Planning Permit Application Referral, PLN2006-00494
(La Costanera Restaurant at Montara State Beach)

MCC comments, 12/12/12
(Early comments to Planning staff on amended application – prior to
environmental documents or staff report.)

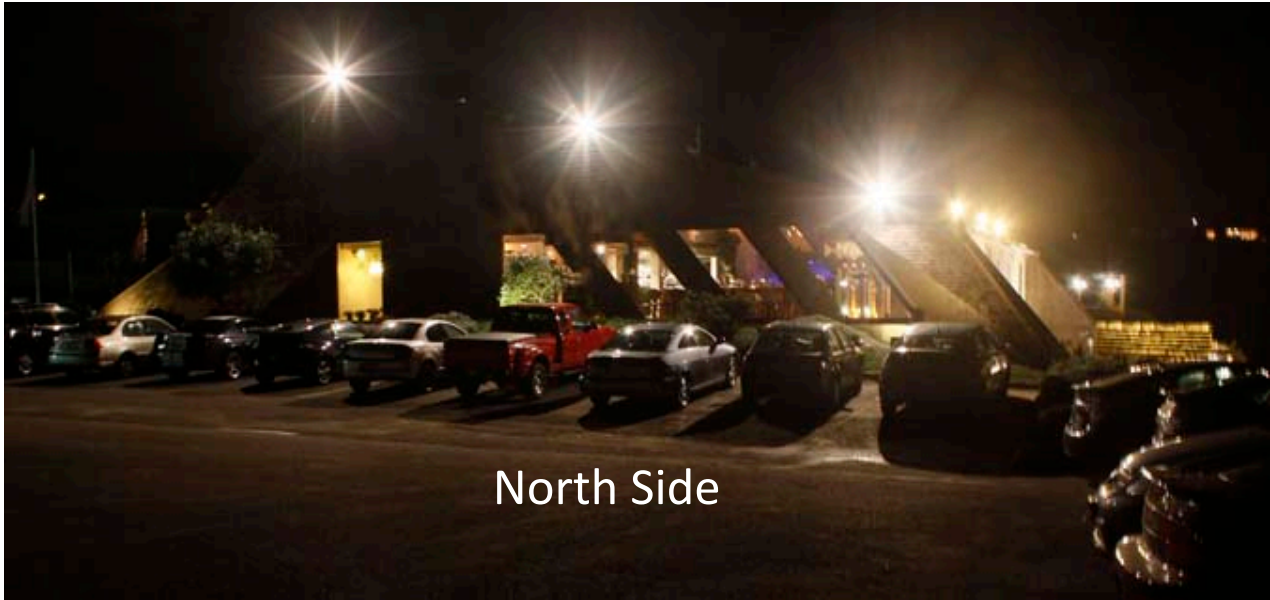
Extra signs, banner, lighting vs. Scenic Corridor

Advertising banner on tallest pole.
National flag on shorter pole
is left out in darkness and rain.

Flood lights
along roof line.

Extra unpermitted sign in CalTrans ROW,
advertising as yet unpermitted use.

West Side from the beach

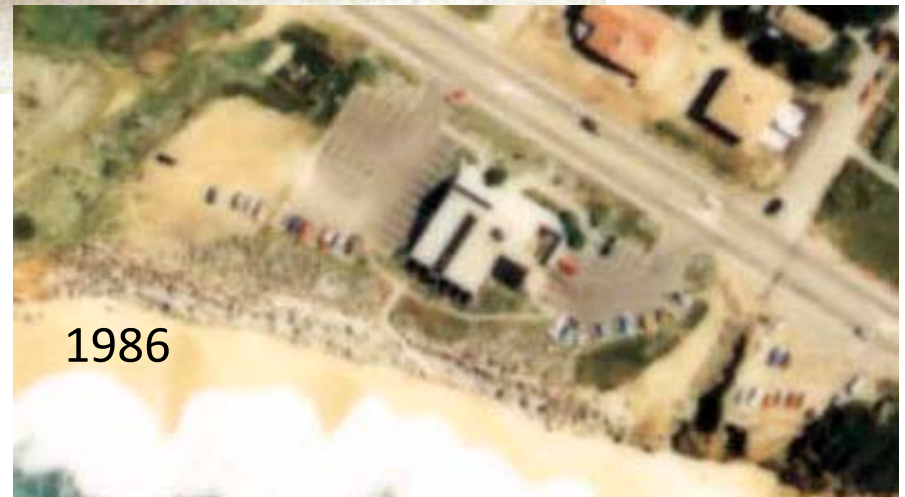
Roof-mounted exterior floodlights

across beach and parking lots
